## **King's Somborne Neighbourhood Plan – Site Options and Assessment – DRAFT Report – Prepared by AECOM – February 2021**

### **Evidence-Based Observations – Consultation held 4<sup>th</sup> to 11<sup>th</sup> February 2021.**

**NDP – Site Options and Assessment DRAFT Report – Collated evidence-based observations for AECOM’s consideration when finalising their report. February 2021.**

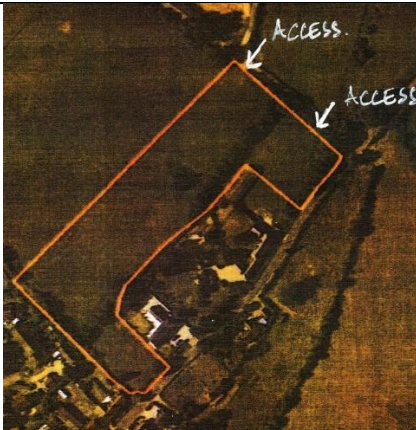
137		Availability	Should Remain	E-mail from Agent 11/02/21	AC55

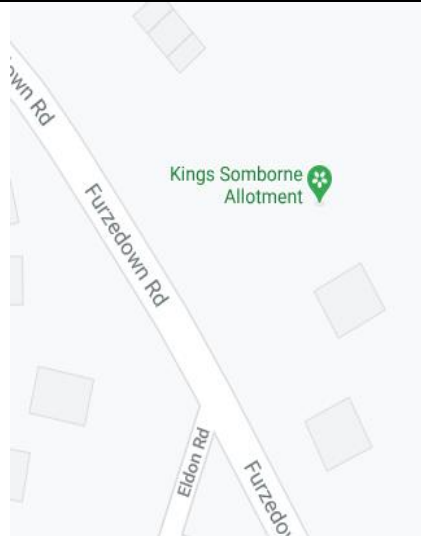
224			The Waterco report advises that surface water discharge rates should be controlled by use of attenuation tanks. Because of the village topography, three of the amber rated sites are adjacent to flood zones 2 or 3, so any such attenuation tanks, by definition, would be located below the AOD (Above Ordinance Datum) of the adjacent zones 2 and 3, rendering them useless during 1 in 100 year flood events (such as in 2002 and 2014) because they would be below the water table and full. It is understood that the houses built on such sites would be designed not to flood, but the flood risk from hard surface runoff to adjacent existing properties would increase. I believe the AOD level data in the Waterco report is sufficient evidence to downgrade sites 3, 80 and 81 to red, due to the increased risk of flooding to existing neighbouring properties.	Waterco Flood Risk Study – August 2018	R3+	
224a			Observation included against Sites 3, 80 & 81, as text specifically refers to these 3 sites. Just to clarify, as requested, I make the following representation on behalf of a number of parishioners. It was agreed at a Parish Council meeting that minimising flood risk is the single most important issue for which the Parish Council can support the local community. Credit to		R3+

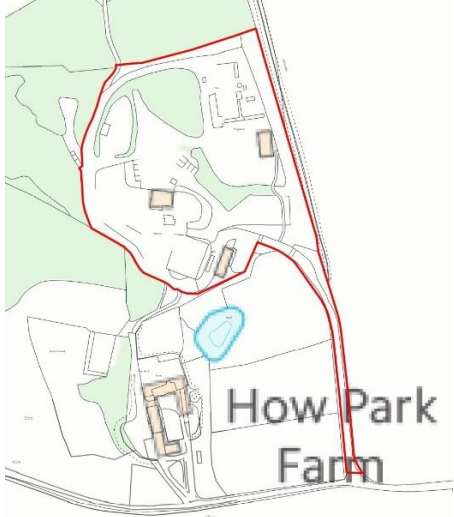
282	216		Visual sensitivity text should be red	This report	CL7	
283	219		Overall rating text should be amber and in the justification it states site has medium sensitivity but part is red see page 216	This report	CL7	
<b>Site 186 – Allotments, Church Road, King's Somborne – Summary of Assessment Findings – pages 46 to 47; Appendix A – pages 220 to 227</b>						
	<u>Page</u>	<u>Section</u>	<u>Observation / Error Identified</u>	<u>Your Evidence Source</u>	<u>contribut or</u>	<u>AECOM – Decision to include/not include. With Reason - for consultation evidence trail</u>
284	46	Header	Site name is incorrect. It is Furzedown Road and Church Road		AC186	
285	46	Header	The aerial photograph is of site 168 and not 186		AC186	This has been amended in a later version
286	46	Current Use	The current use is as allotments and not agriculture	See aerial photograph above.	AC186	
287	46	SHELAA Conclusions	The site is available and promoted for development by the land owner, with interest from a developer. The site is		TV1
